20240610 – BL000B – MULTI-BUILDING – BL107, BL405 – Replace Humidifiers
Addendum 2

November 4, 2025

Changes to the Drawings

M101

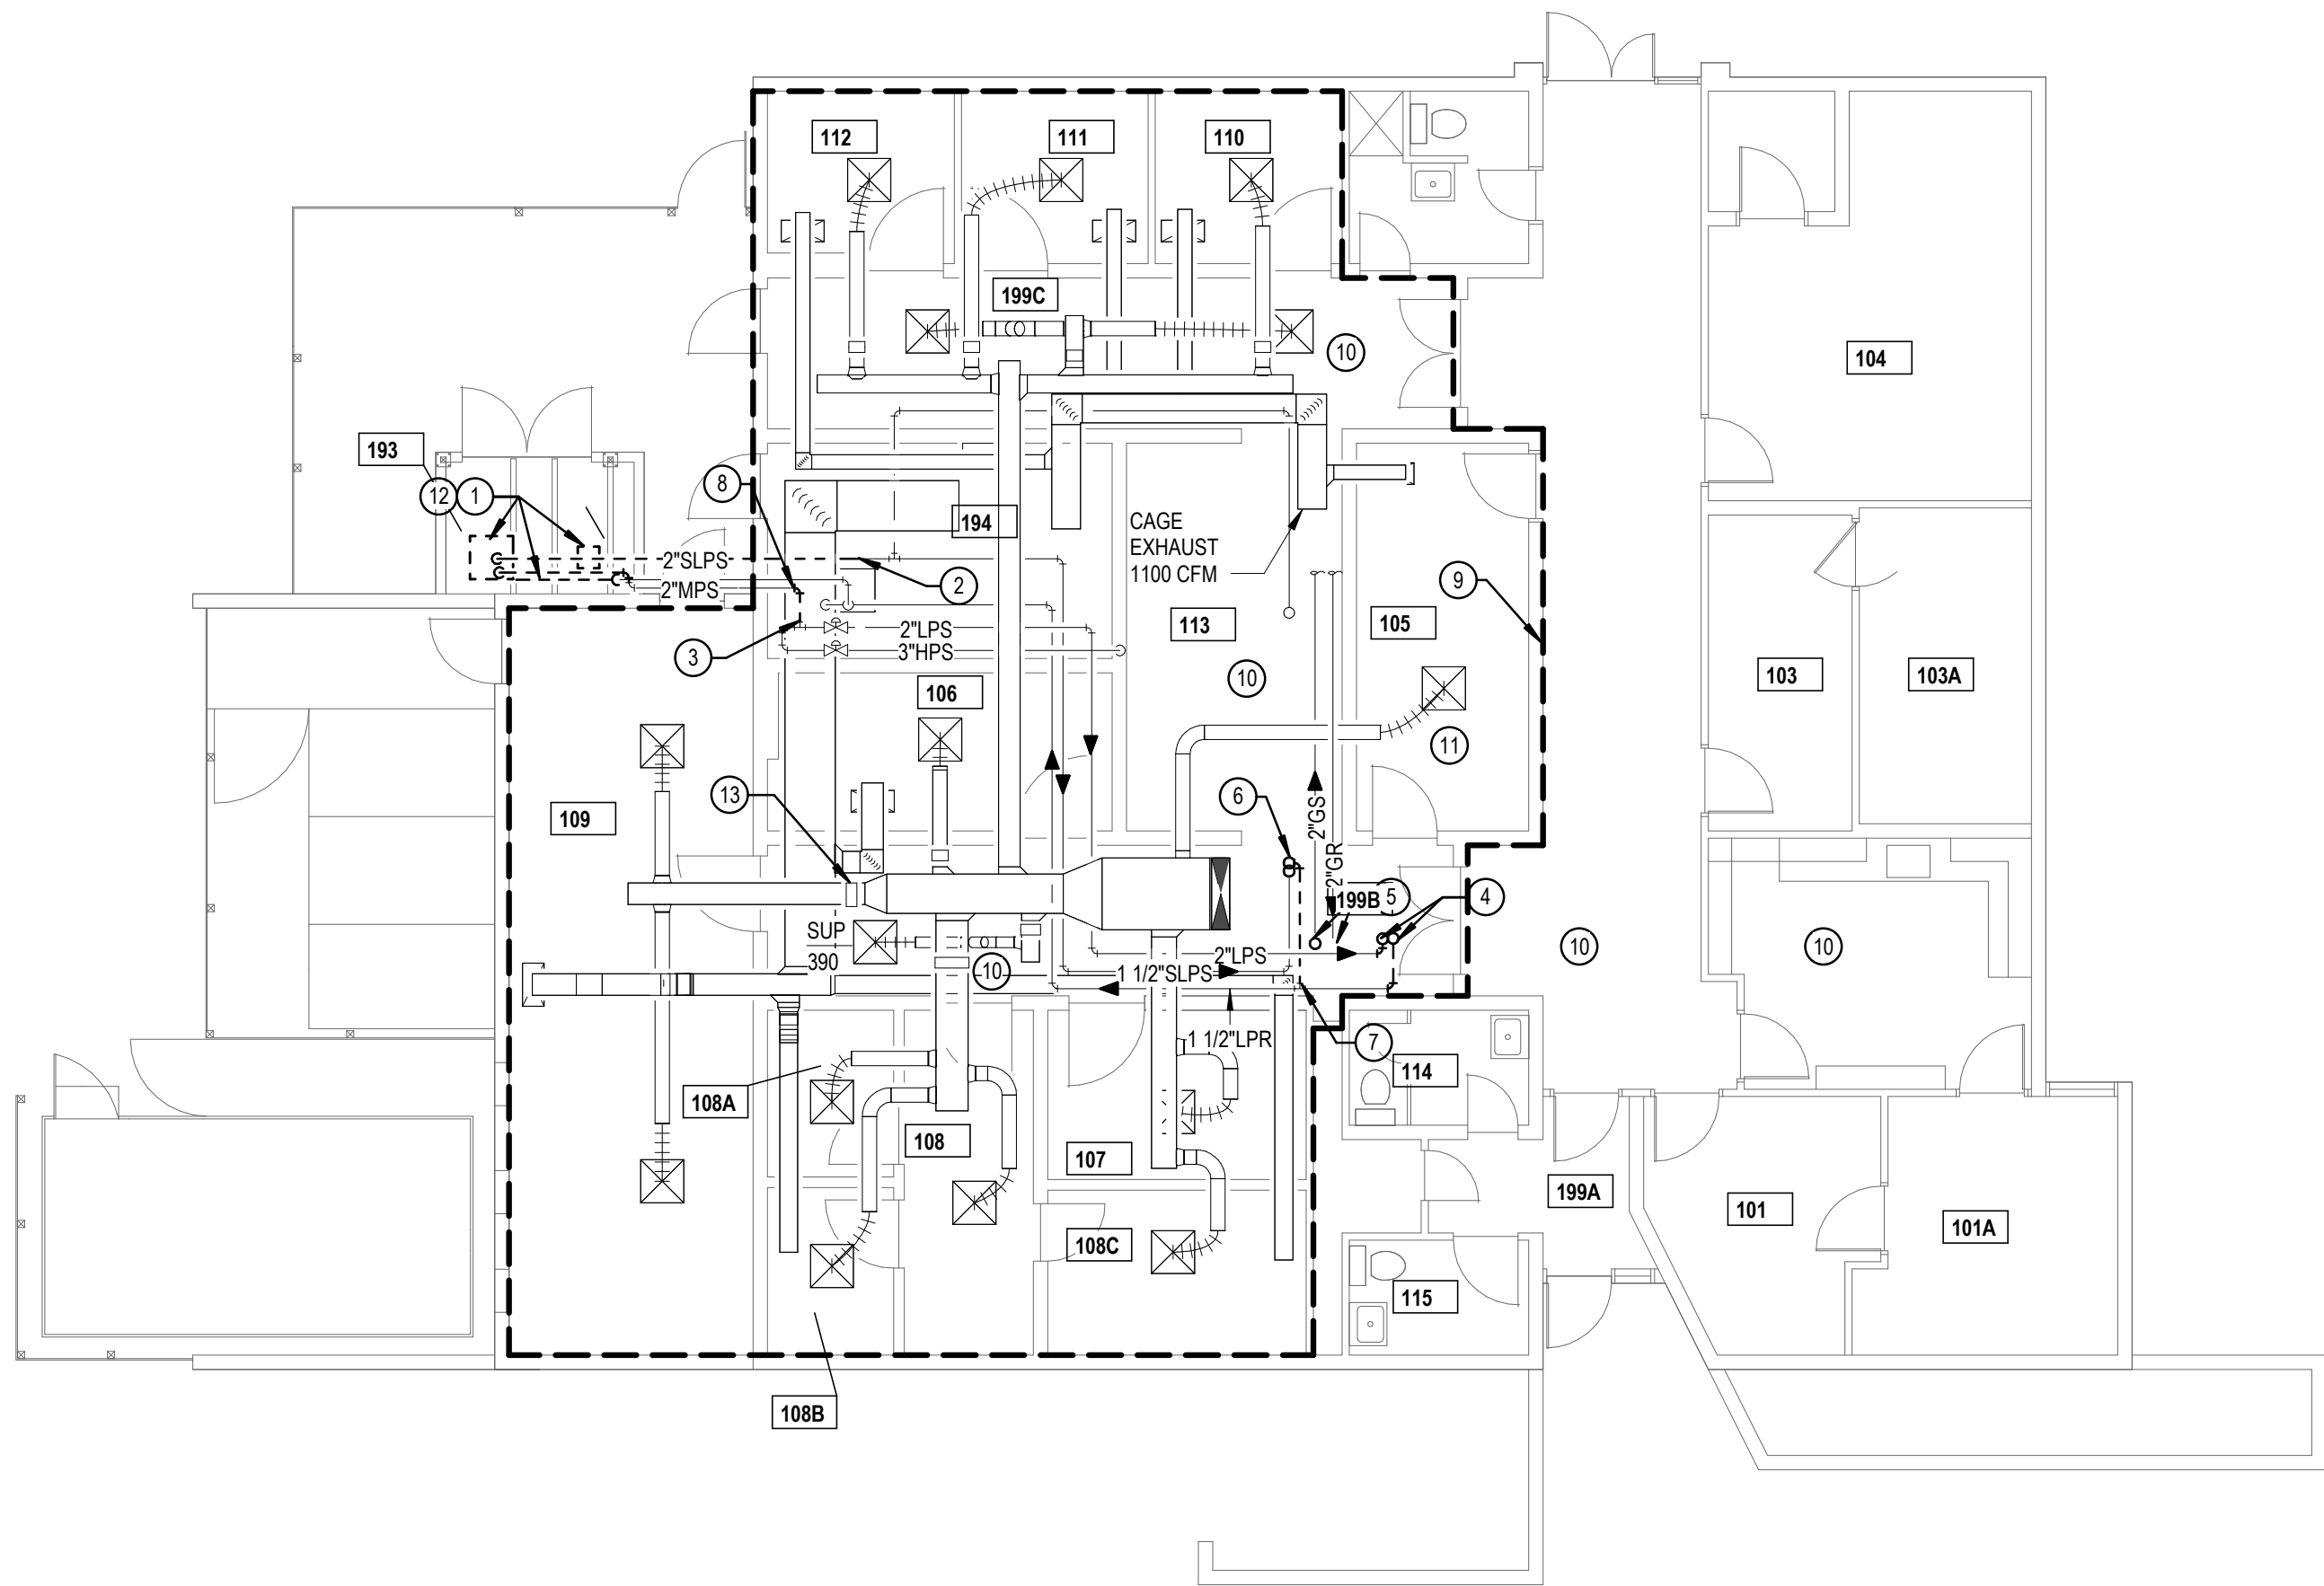
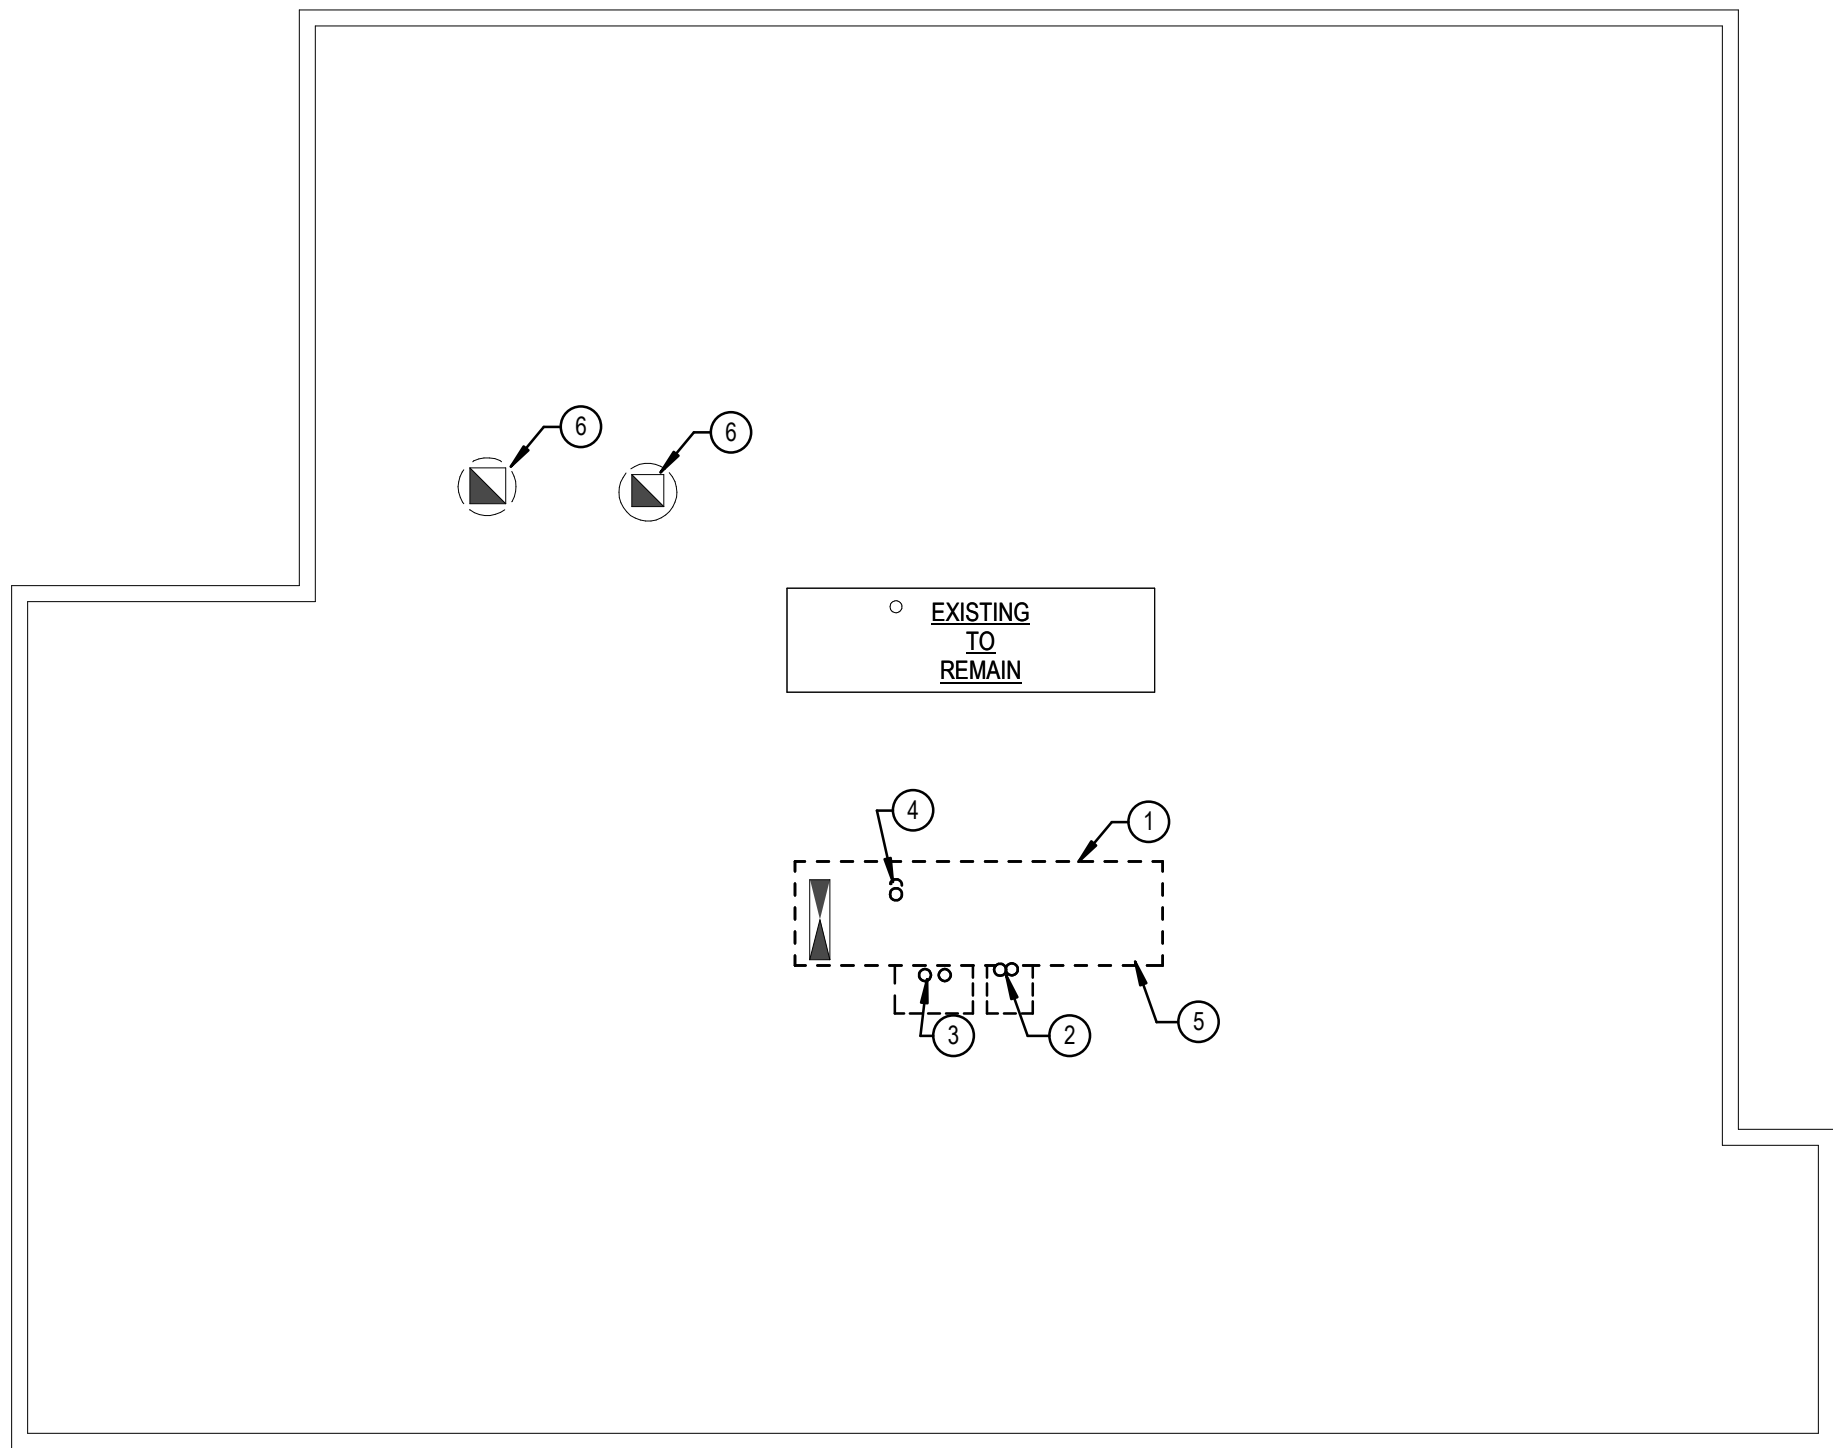
1. Sheet S201 – Partial Roof Framing Plan
2. Sheet M101 – Research Service Building – First Floor and Roof Mechanical Demolition Plans
3. Sheet M201 – BL405 – Research Service Building – First Floor and Roof Mechanical Plans
